BCA Assessment Report

45 Lantana Avenue, Wheeler Heights

| Reference No: | 112947-BCA-r2 |

| Revision | Date | Description | |
|---------------|------------|---|---|
| 112947-BCA-r2 | 7/12/2020 | BCA Assessment Report (DA Stage) | |

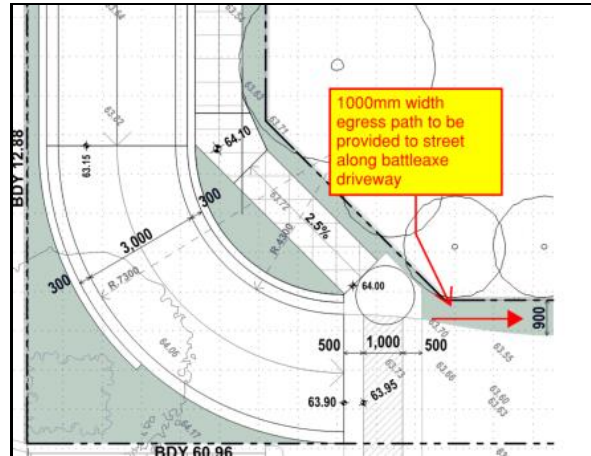
1. An external egress path shall be provided to the street via the battleaxe driveway. The walkway shall have a gradient of not more than 1:20 otherwise a handrail will be required in accordance with BCA Clause D1.10.

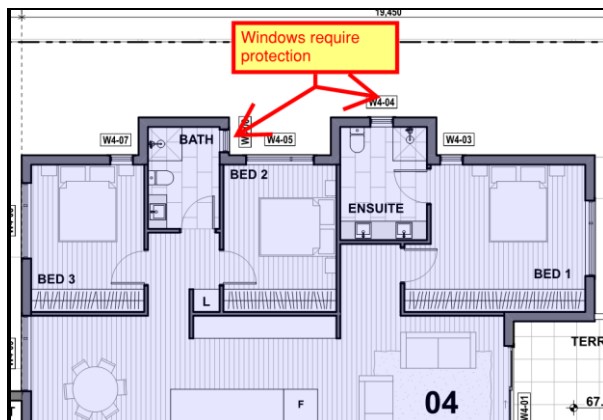
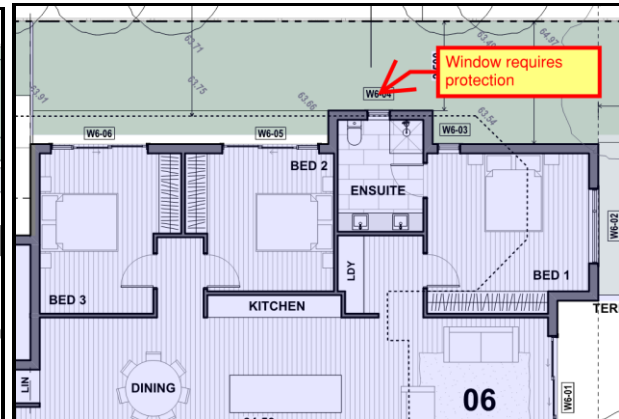
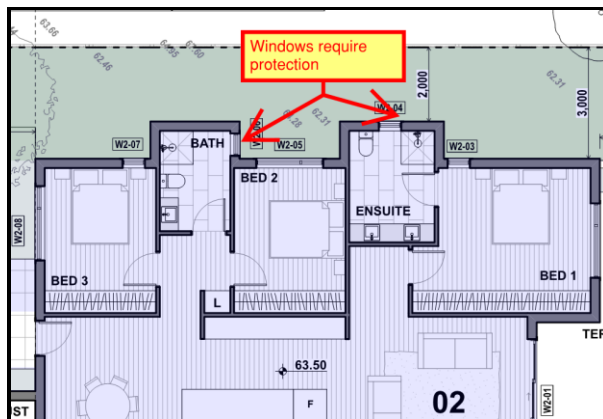
2. The ensuite and bathroom windows to Units 2, 4, 6 & 7 are located within 3 metres to the western boundary and require protection in accordance with BCA Clause C3.2/C3.4.

Note: If it is possible to justify a fire engineered performance solution in accordance with BCA Clause C1.5 to reduce Type of Construction to Type C Construction then it will not be necessary for protection of openings to be applied as the building is greater than 1500mm to boundary.

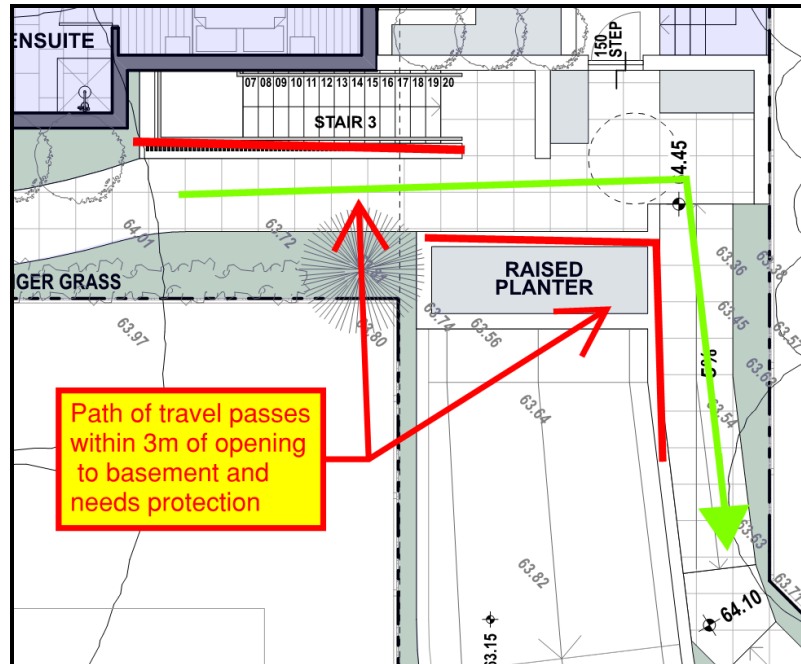
3. The external exit path from the rear building travels within 3 metres of openings to the carpark and results in a technical non-compliance with BCA Clause D2.12.

It is recommended to provide an FRL --/60/30 fire door at the base of the front stair aswell as a minimum 1000mm solid balustrade to afford occupants radiant heat protection as they travel past the openings.

Furthermore, it will be necessary for a fire engineered performance to permit there being openings within 3 metres of the path of travel.

Figure 28 in AS 1428.1:2009

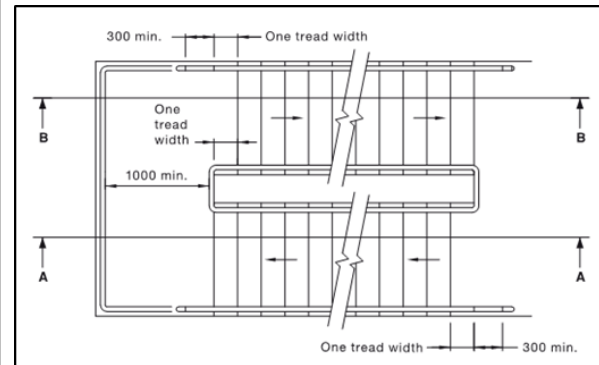
Note: The handrail to the main residential non-fire isolated stair currently extends up continually around stair flights and landings and to the top landing. The issue with this design is that the handrail is to be in the range 865-1000mm throughout stair flights but more than 1000mm where landings are more than 500mm length. And at the top landing the handrail needs to comply with Clause 11 of AS1428.1-2009 and have a 300mm horizontal extension at 865-1000mm rather than transitioning up to 1000mm+ balustrade height. Therefore, with design development it is recommended that the handrail is provided separate to the balustrade at the landings otherwise a non-compliance will occur.

The handrail shall follow the angle of the nosings and be consistent height through the stair flight and any landings with no vertical sections at the landing. Compliance can be achieved via offset risers at the bottom of the flight in accordance with Figure 28 in AS 1428.1:2009 or with larger landings to accommodate required handrail extensions.
